Re: Academy Village Filing Number 3- Drainage Addendum Letter

This letter is an addendum to the “Final Drainage Report for Academy Village” dated April 1999, prepared by HMS Group, LLC. This addendum will address the reconfiguration of the drainage pattern within basin 1a of the approved report. The purpose of this addendum is to quantify the changes to the drainage condition due to site variations from the approved report.

ACADEMY VILLAGE
 DRAINAGE PLAN

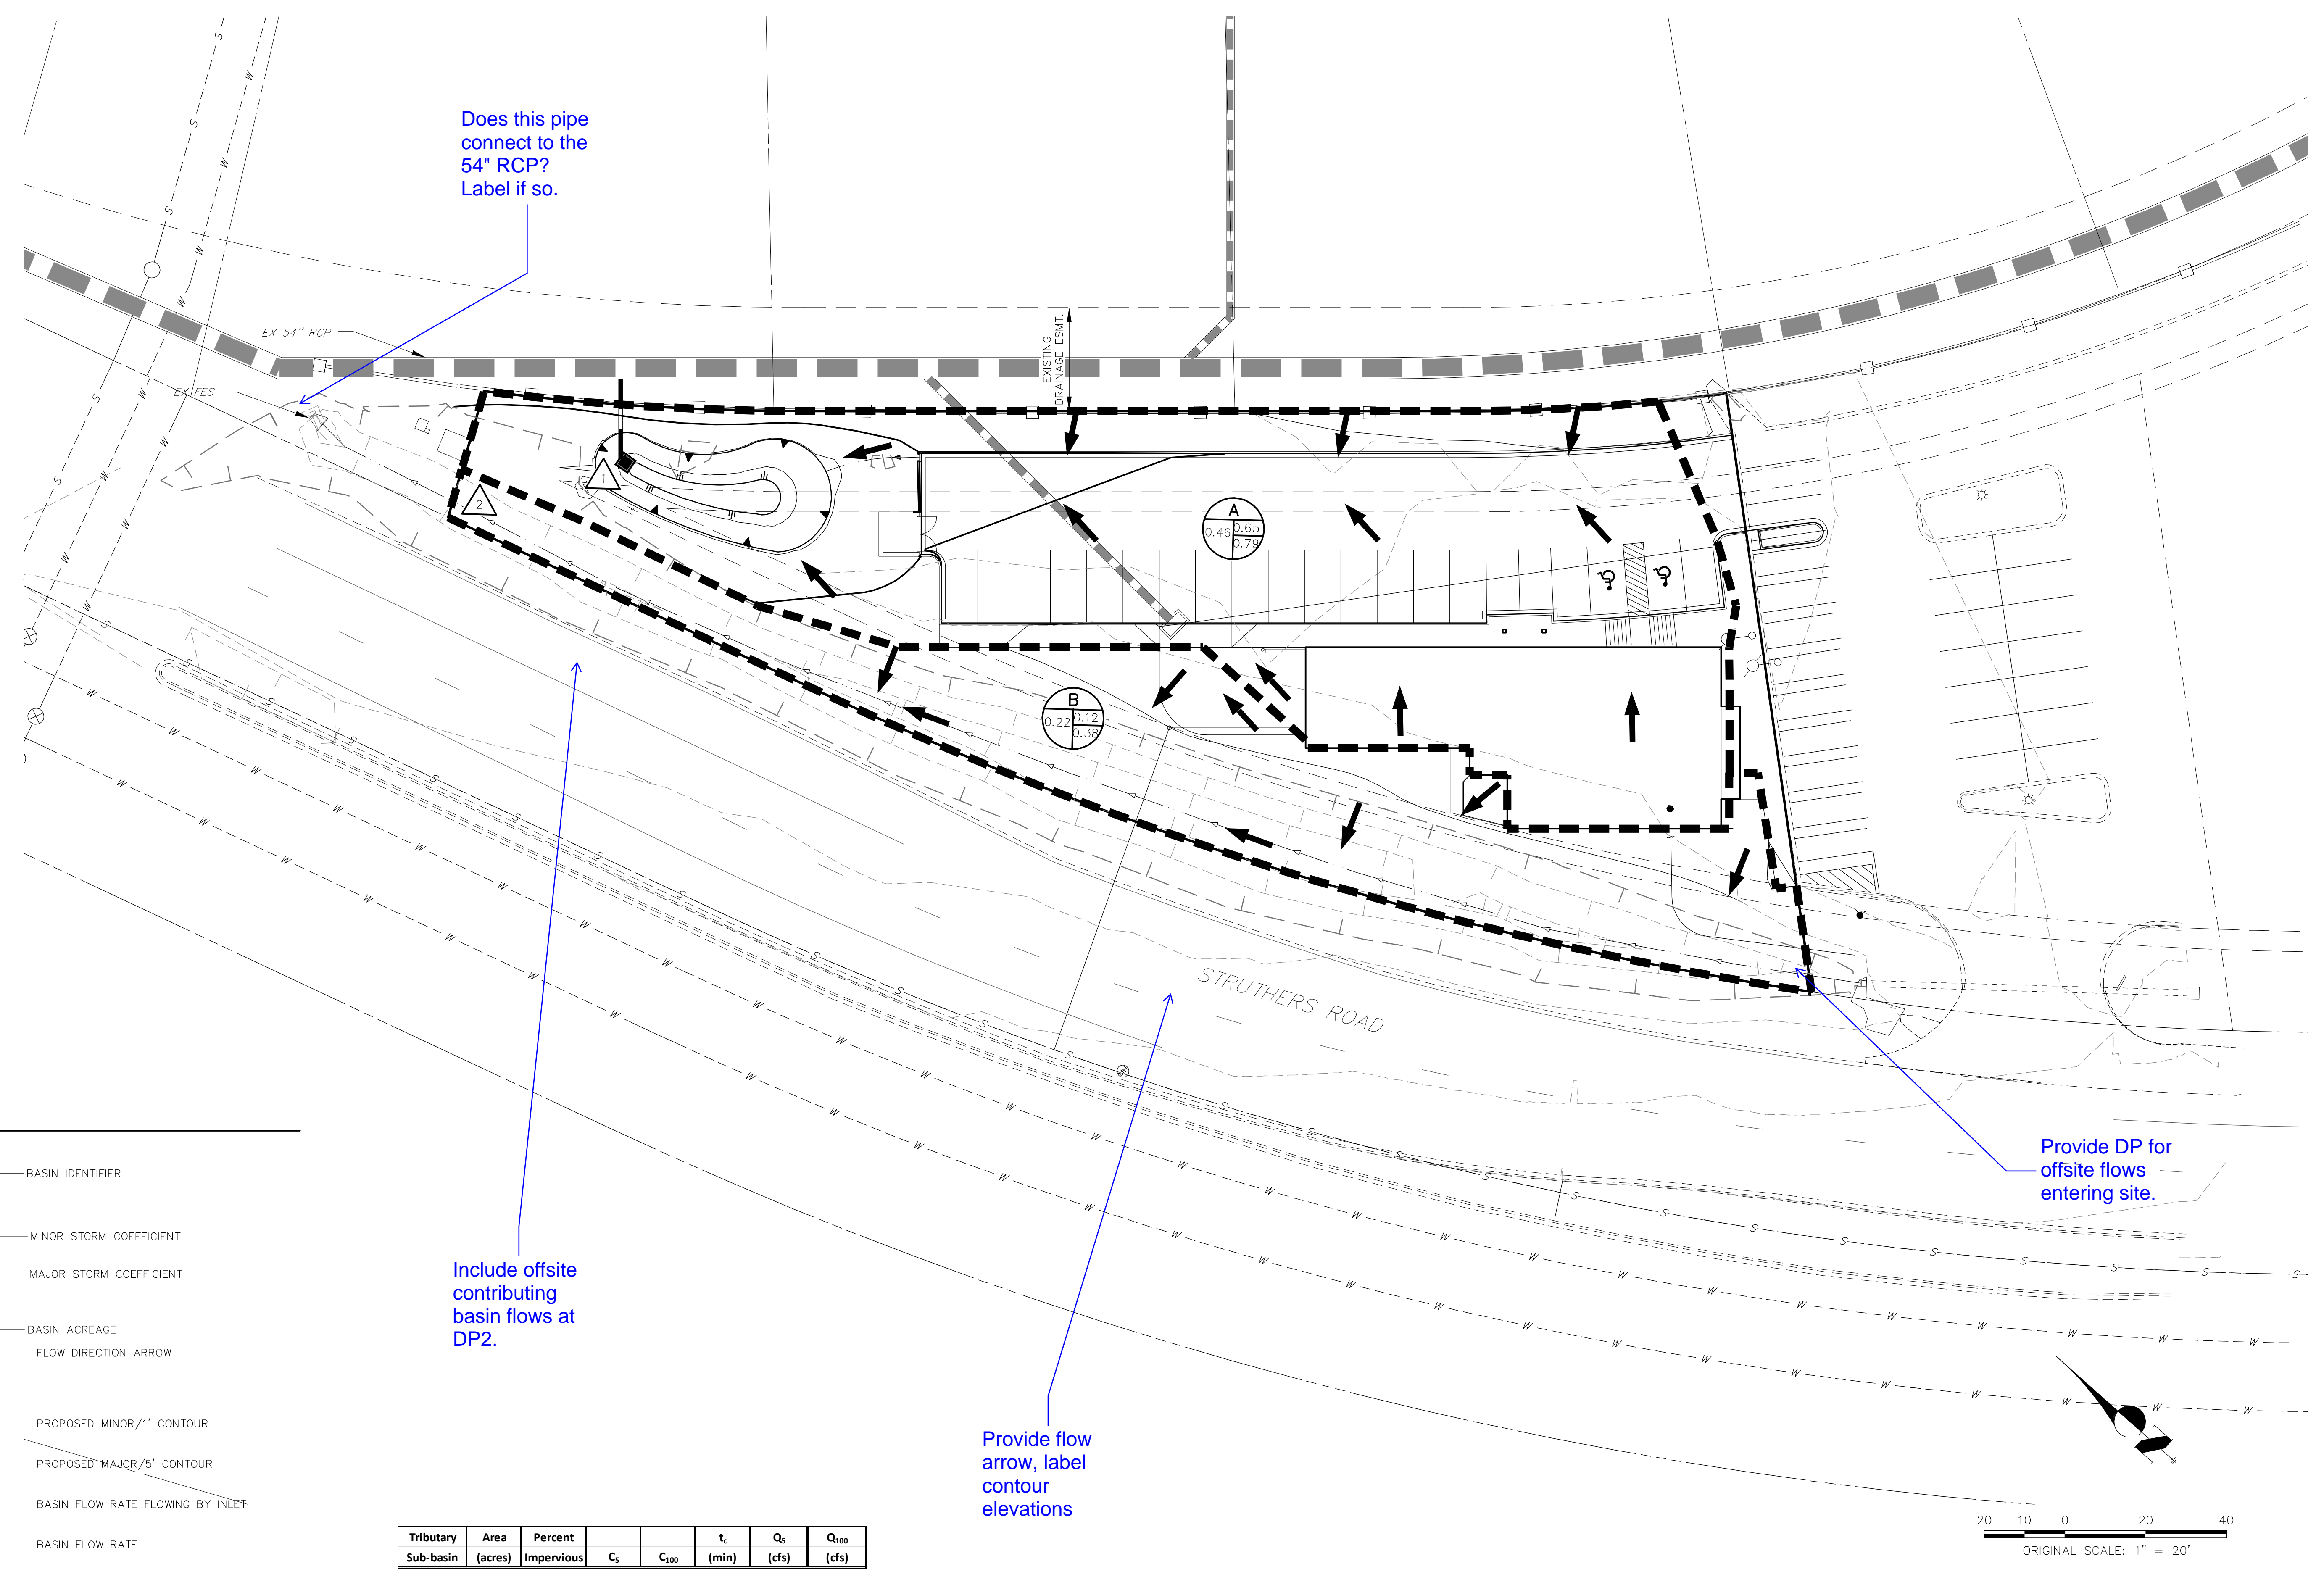
Provide Sheets 1 and 2

Provide DP for offsite flows entering site.

Does this pipe connect to the 54" RCP? Label if so.

Include offsite contributing basin flows at DP2.

Provide flow arrow, label contour elevations
